Re: *Shared Parking Study & Parking Management Plan
Cornerstone Mixed Use Development
Agoura Hills, CA*

Thank you for passing along the City's comments related to Walker's Shared Parking Study and Parking Management Plan for the proposed Cornerstone Mixed-Use Project. We have provided the response to specific comments within the body of this letter (below). All comments noted as addressed within the body of the report, are incorporated within the attached document.

Figure 1: Market Area

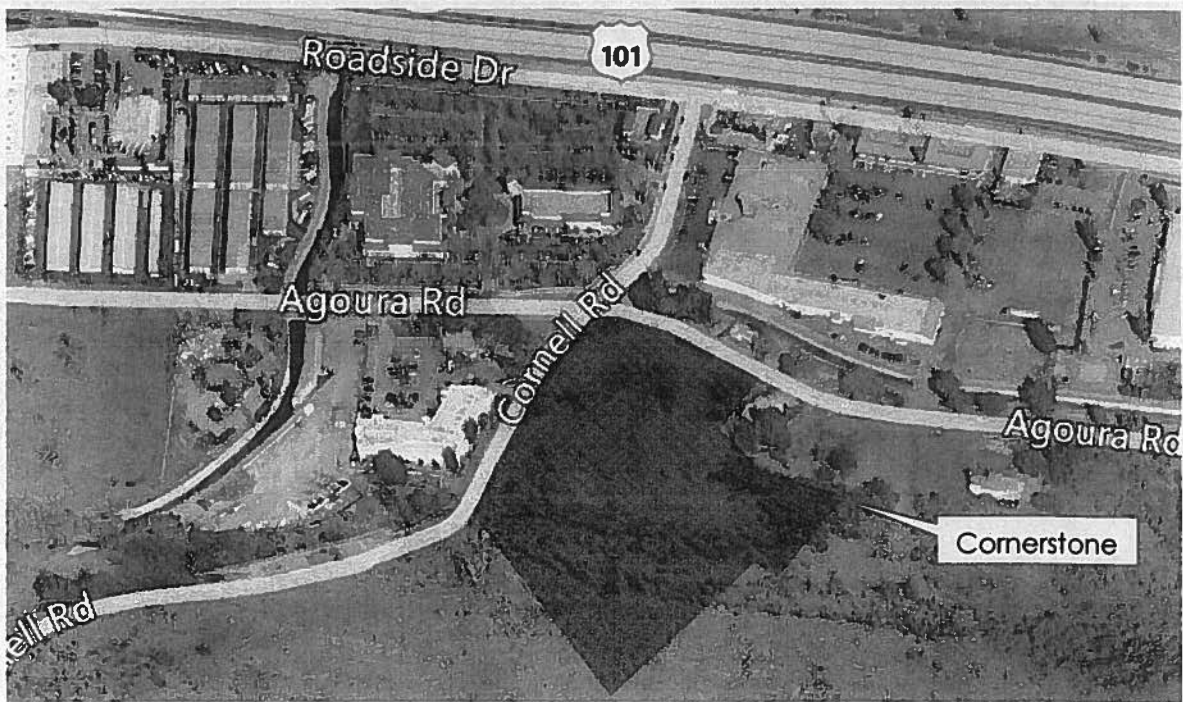
Comment #1 (page 3)

Figure 1 -has been adjusted
